PNG WEST 2020-2021 REVENUE REQUIREMENTS EXHIBIT A-3
--

**Re: Pacific Northern Gas Ltd. – PNG-West Division – 2020–2021 Revenue Requirements Application –
Project Number 1599059 – Information Request No. 1**

INFORMATION REQUEST NO. 1 TO PACIFIC NORTHERN GAS LTD.

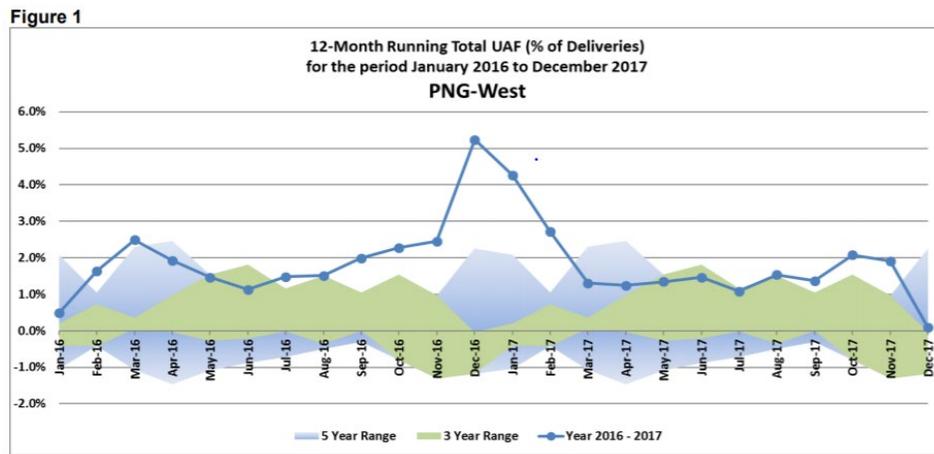
- 6.1 Please discuss any specific reasons why there have not been offsetting gains and losses in UAF gas in 2015 to 2019 as compared to the 2004 to 2014 time period.
- 6.2 Please explain how the UAF loss percentages on PNG-West’s system compares with other gas utilities with similar systems to PNG.
- 6.3 Please provide the actual UAF losses, total deliveries, the UAF losses as a percentage of deliveries and the value of UAF losses for each year between 2004 and 2019.
- 6.4 For each year of the five-year period from 2015-2019, please explain the reasons for the UAF losses. In your response, please also explain how each of the primary drivers of the UAF volumes affect UAF losses for that year.
